DUANE ARNOLD ENERGY CENTER

AMENDMENT TO FACILITY OPERATING LICENSE

Amendment No. 224
License No. DPR-49

ATTACHMENT TO LICENSE AMENDMENT NO. 224

Figure 3.4.9-1 (page 1 of 1)

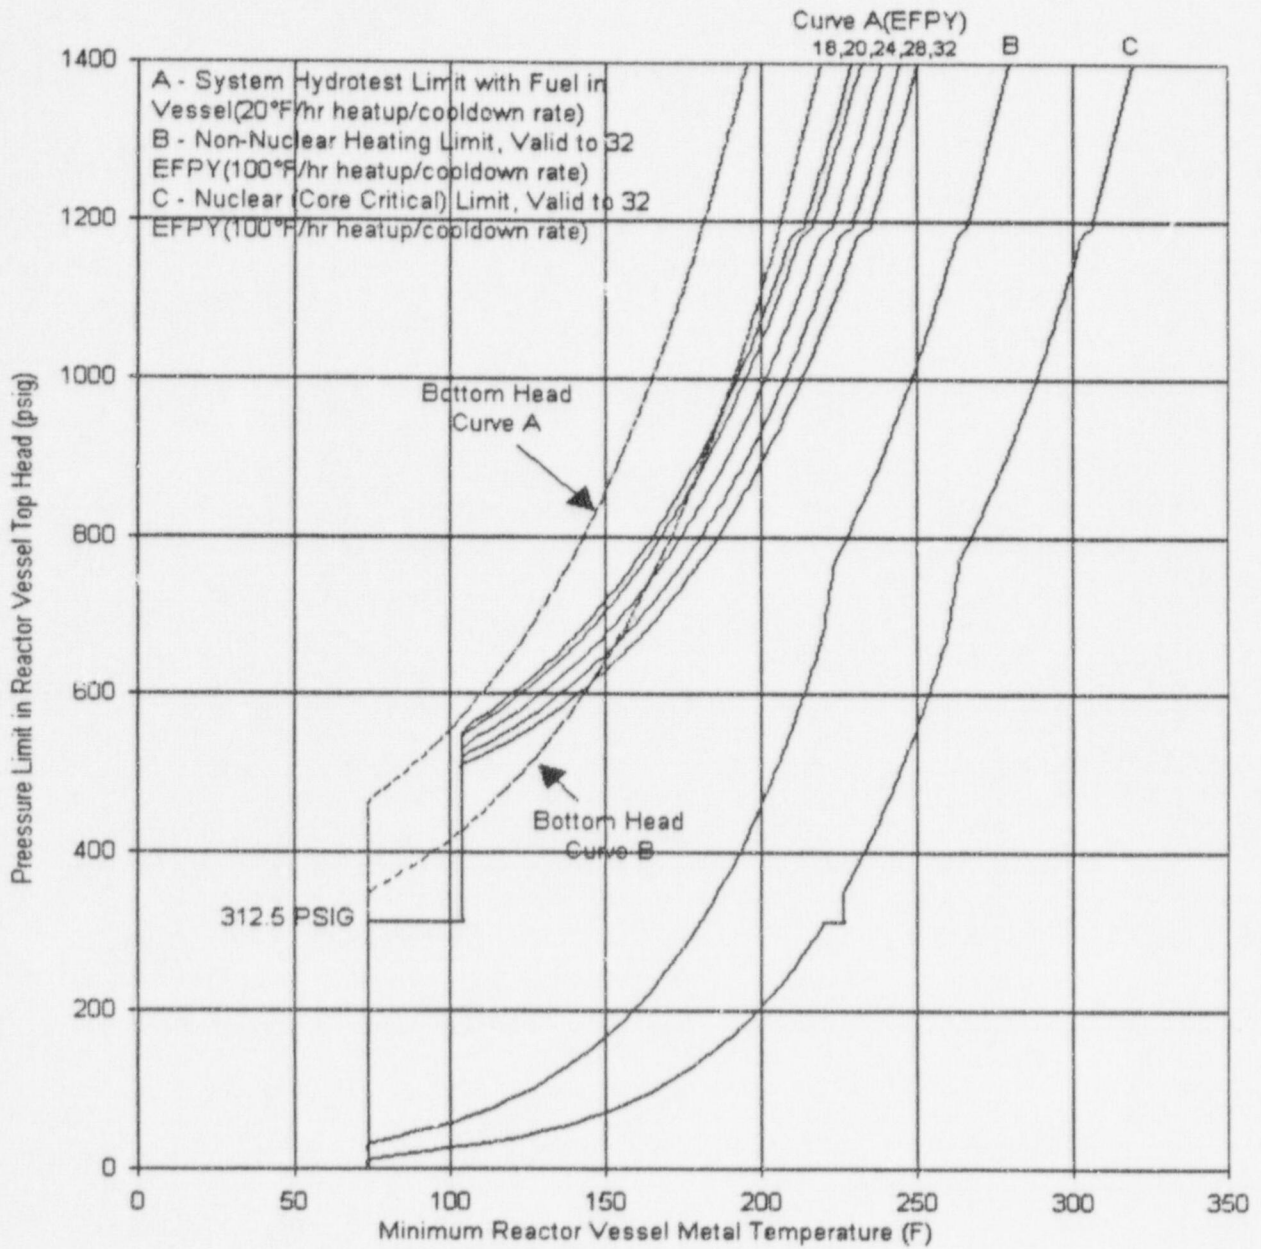
Replace the following pages of the Appendix A Technical Specifications with the enclosed pages. The revised areas are indicated by vertical lines.

Pressure Versus Minimum Temperature Valid to Thirty-two Full Power Years, per Appendix G of 10CFR50
